## DEVIATION REQUEST AND DECISION FORM

Project Name :	Waterview East Commercial
Schedule No.(s) :	509200002
Legal Description :	TR IN SEC 9-15-65 DESC AS FOLS: COM AT THE N4 COR OF SD SEC 9, TH S00-19-23E ALG THE N/S CEN LN OF SD SEC 1613.76 FT TO A PT ON THE SLY ROW LN OF BRADLEY RD, TH S89-30-29W 3.77 FT, TH ALG THE ARC OF A CUR TO THE L HAVING A RAD OF 2759.79 FT, A C/A OF 15-09-41, ARC DIST OF 730.29 FT, WHICH CHORD BEARS S81-55-38W, DIST OF 728.16 FT, TH S74-20-48W 930.15 FT TO THE POB; TH S15-39-12W 394.68 FT, TH ALG THE ARC OF A NON TANG CUR TO THE R, HAVING A RAD OF 75.00 FT, A C/A OF 43-29-55, ARC DIST OF 56.94 FT, WHICH CHORD BEARS S36-01-21W, DIST OF 55.58 FT, TH S57-46-18W 68.47 FT, TH ALG THE ARC OF A CUR TO THE L, HAVING A RAD OF 450.00 FT, A C/A OF 35-44-30, ARC DIST OF 280.72 FT, WHICH CHORD BEARS S39-54-03W, DIST OF 267.19 FT, TH S67-58-24E 40.00 FT, TH S22-01-36W 538.15 FT, TH ALG THE ARC OF A CUR TO THE R, HAVING A RAD OF 260.00 FT, A C/A OF 13-32-35, ARC DIST OF 61.46 FT, WHICH CHORD BEARS S28-47-53W, DIST OF 61.31 FT, TH S00-00-00W 148.75 FT, TH N90-00-00W 515.00 FT, TH N00-29-10W 1123.38 FT, TH ALG THE ARC OF A CUR TO THE R HAVING A RAD OF 150.00 FT, A C/A OF

Deviation Exhibit 2  
**Proposed Right-in-Only  
Access and Site Plan**

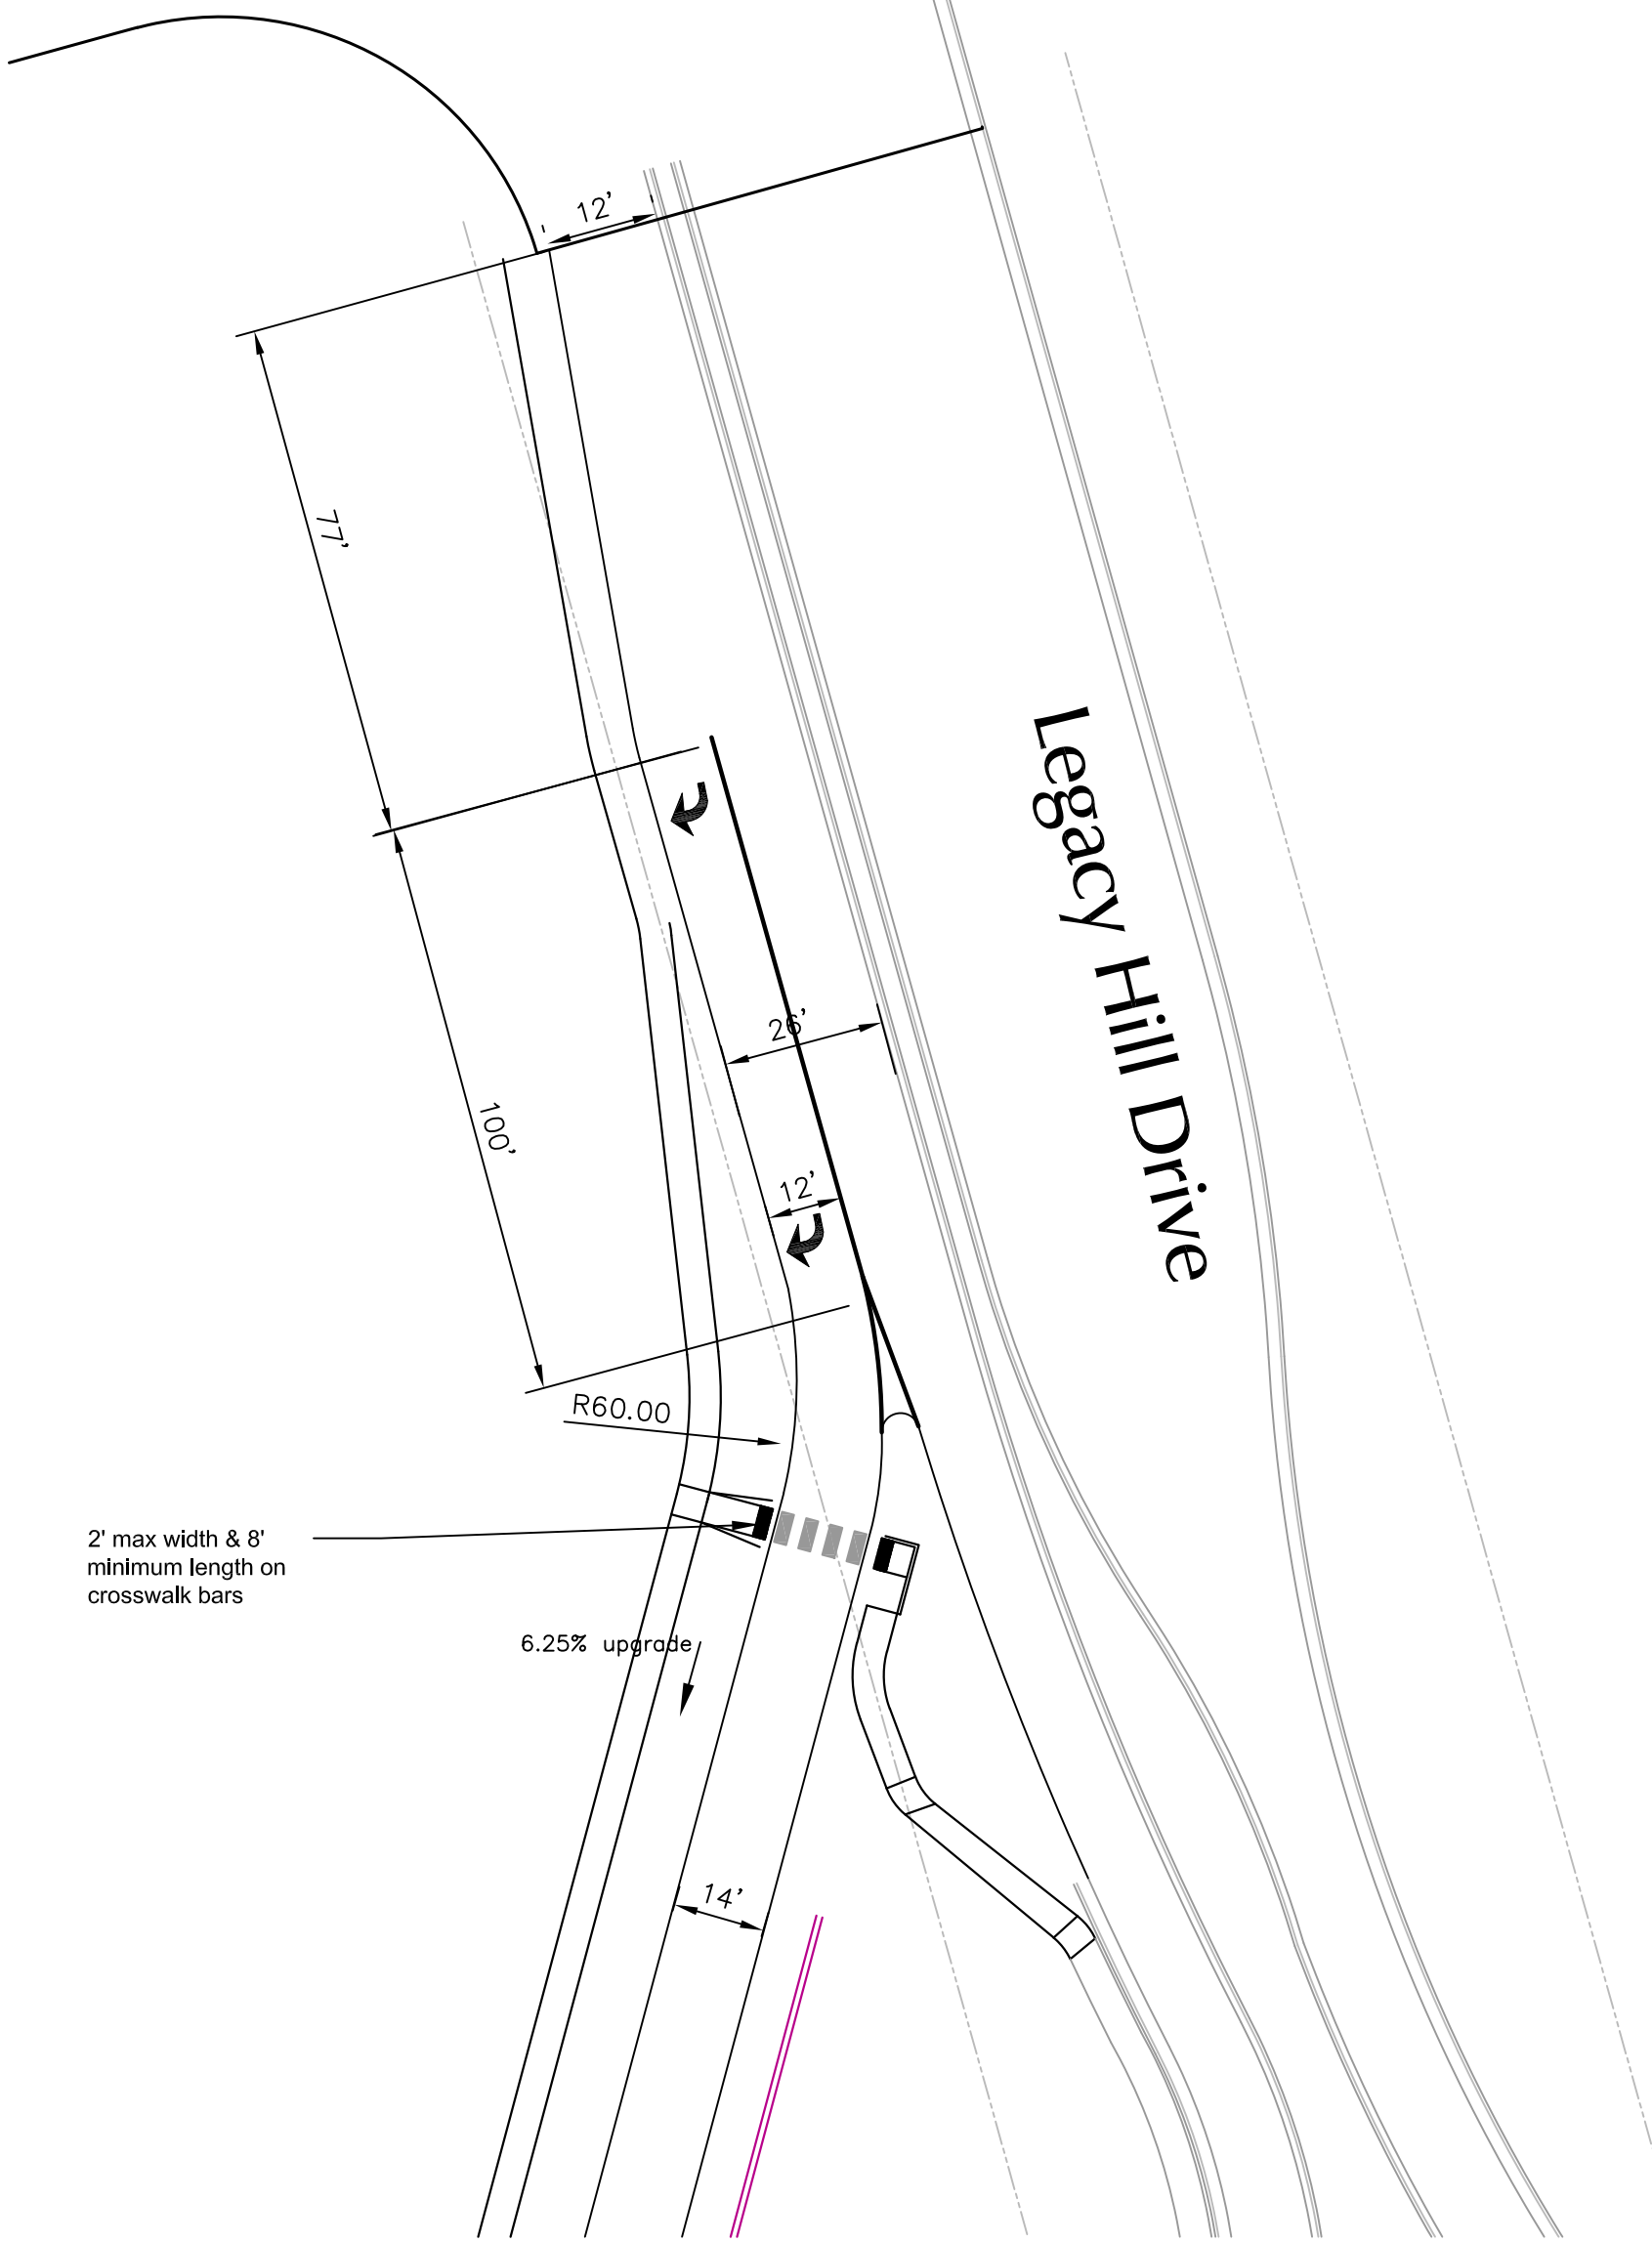
Exhibit 1 shows the location of the Waterview East Commercial development and Exhibit 2 shows the location of the proposed right-in-only access for which this deviation to the *ECM* criteria is requested. The applicant is requesting this access to improve access to the site as no access will be allowed to the west to Powers Boulevard (classified FW Freeway) or to the north to Bradley Road (an Urban Minor Arterial). Without this deviation, there would only be access to/from one side (the south side) of the development. This would hamper the marketing of the development, especially the proposed gas station/convenience store site on the "hard corner" of Bradley Road/Legacy Hill Drive. It would also be detrimental to the viability of the site and competitiveness in the market.

The deviation is a request for a right-in-only, restricted turn-movement access to the west side of Legacy Hill Drive about 345 feet south of Bradley Road (Centerline spacing). The ECM standard is NO private access to a Collector street. A private, one-way, internal commercial street would extend southwest from this access into the site.

*Access to commercial or industrial parcels fronting Nonresidential Collector roadways shall be located a minimum of 115 - 480 feet from the point of curvature or point of tangency of the curb line at the intersection depending on the sight distance and location with respect to the intersection, intersection control, and posted speed. Please refer to Deviation Exhibit No. 2 for spacing dimensions.*

Deviation Exhibit 3  
Right-in Only Access Design

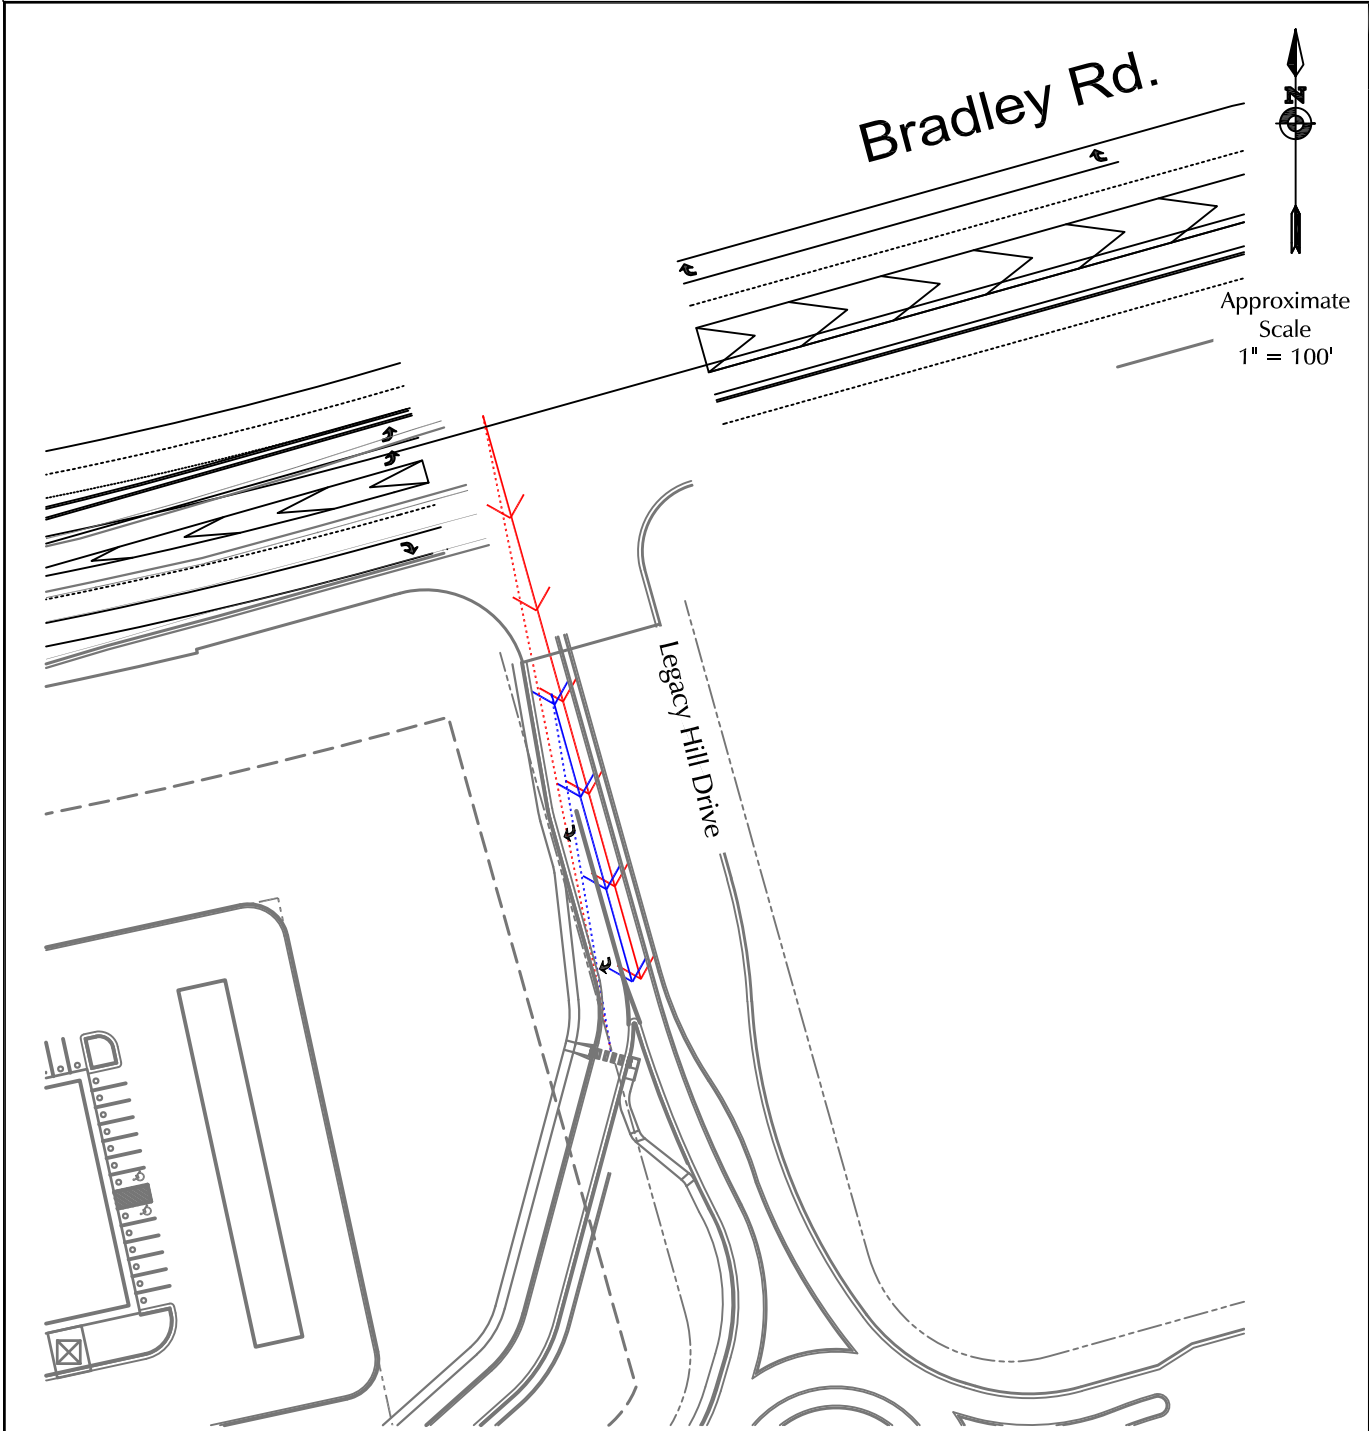
The proposed right-turn lane would have abbreviated lane and taper lengths. The ECM standard is 155-foot lane plus 160-foot taper, plus storage. Deviation Exhibit 3 shows the proposed lengths. The abbreviated lengths will be mitigated by the proposed 60' corner radius and skewed (obtuse) angle. This is described in the operations section below.

The obtuse angle of the access, combined with the larger-than-standard 60-foot corner radius, would allow for right turns from Legacy Hill onto the access drive at a higher turning speed, which would result in a reduced speed differential between southbound through traffic and right-turning traffic. This will mitigate the shorter length of the right-turn bay and provide a much easier right-turn movement. Right-turn-lane **stacking distance** is not needed, as the turn off Legacy Hill will be a "free" movement (except for the infrequent need to yield to crossing pedestrians). A pedestrian crossing of this access is shown. However, low pedestrian volumes are anticipated. Exhibit 3 shows the recommended configuration.
